Portland Library, cor. Congress & Elm Streets.

Inasmuch as the plans were preliminary, please bear in mind the following items are perhaps easily explained from your point of view but were not clearly indicated on the plans.

Earle S. Smith Plan Examiner

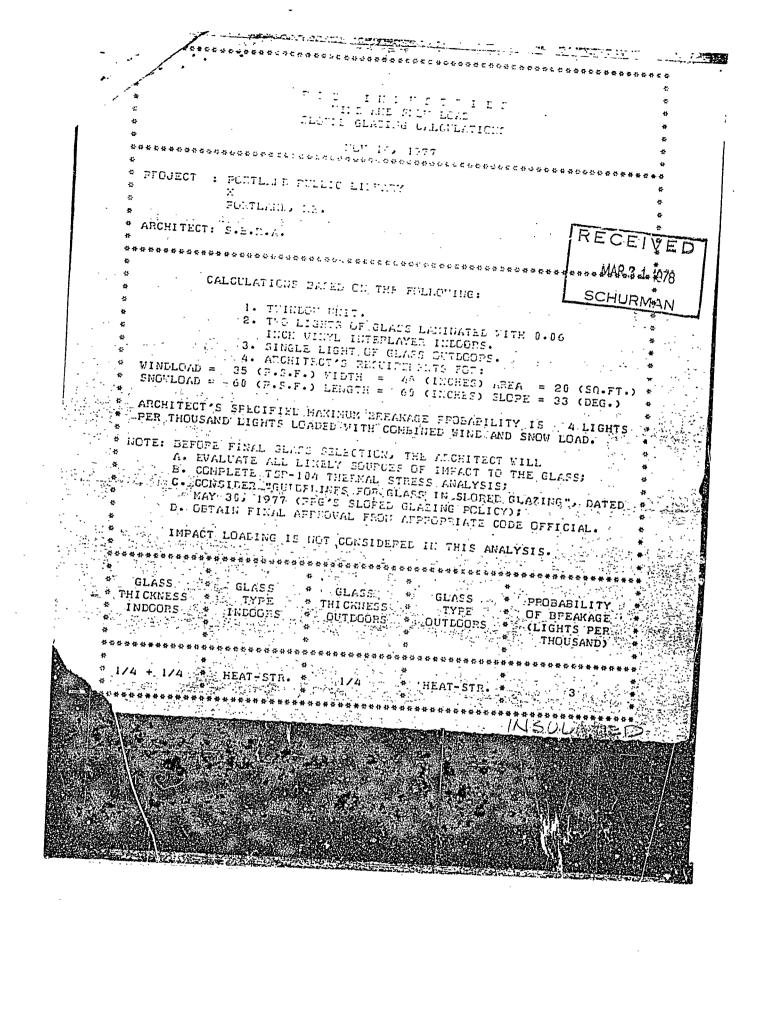
This is in response to your request for a review of the skylights provided for the Portland Public Library.
